RS-14-100

U.S. Nuclear Regulatory Commission
ATTN: Document Control Desk
Washington, DC 20555-0001Quad Cities Nuclear Power Station, Units 1 and 2
Renewed Facility Operating License Nos. DPR-29 and DPR-30
NRC Docket Nos. 50-254 and 50-265Subject: Additional Information Regarding License Amendment Request Associated with
Use of Neutron Absorbing Inserts in Spent Fuel Pool Storage Racks

ATTACHMENT 1
Response to Request for Additional Information

**QCNPNS Composite Areal Density Coupon Results
Based Upon Minimum As-Measured Coupon Values**

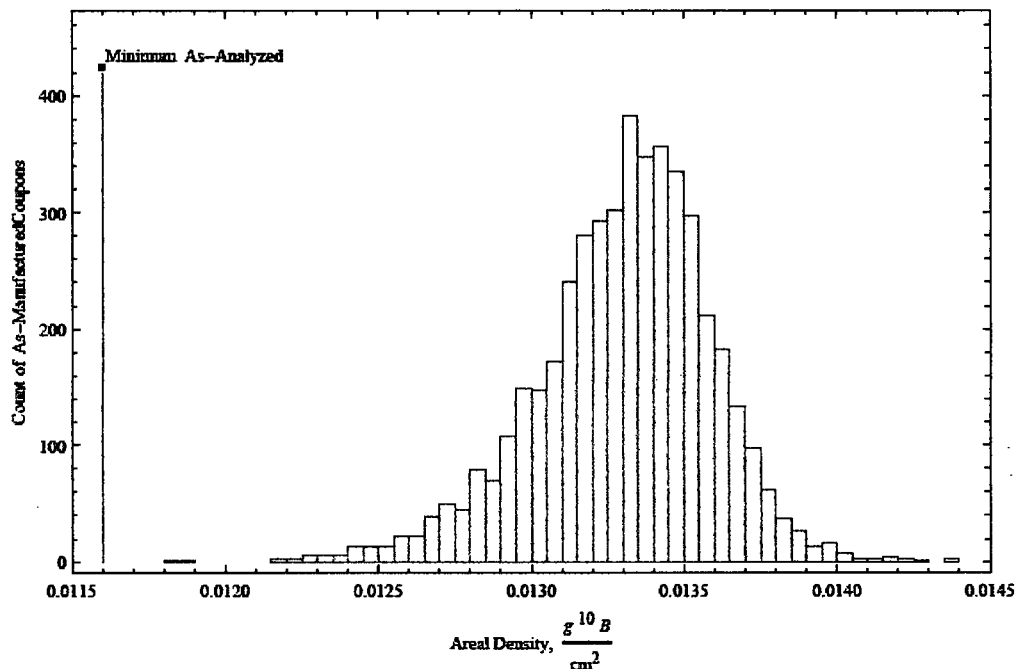
For the 'Super Lattice' cases there is very little margin to the regulatory limit. Section 3.4.2 of Attachment 1 to the July 16, 2013 letter, discusses mechanical wear of the inserts. While the section indicates that minimal insert mechanical wear is expected the minimum as-built areal density of the inserts is the same value as is being used in the NCS. This means that for the inserts which are installed at the minimum as-built areal densities can tolerate essentially no wear of any kind before the insert no longer has the requisite areal density to perform as analyzed. With that in mind provide the following:

- a. Justification of the proposed wear surveillance. NRC staff considers one insert too limited of a sample size and recommends the licensee increase the sample size to three or more. Additionally, the NRC staff considers the licensee's proposed definition of 'high duty' to be limited as it does not appear to consider the potential for a low number of fuel

movements having a higher contact with the insert as being more limiting than a high number of fuel moves with essentially no contact with the insert.

- b. Discuss whether the process of placing the inserts into the rack results in any wear on the insert.

To date, through general observation, there has been no evidence of any uniform mechanical wear on the NETCO-SNAP-IN® inserts at either Peach Bottom Atomic Power Station or LaSalle County Station. If wear were to occur, areal density coupon test results performed for each insert show that significant margin exists to the minimum certified areal density of the inserts.

The histogram below shows the minimum measured areal density values of a quantity of approximately 3,250 test coupons (i.e., one coupon for every sheet, from which two inserts are made) representing inserts manufactured for QCNPS to date.

These results are based upon the minimum measured values of the insert coupons that were cut from the same sheet of material as the inserts. This histogram shows that the minimum certified areal density value, which is labeled on the histogram as "Minimum As-Analyzed," is six sigma less than the average minimum measured areal density of the manufactured inserts. This provides considerable margin sufficient to identify wear phenomena that may occur on the inserts before it would affect their intended reactivity hold-down capability.
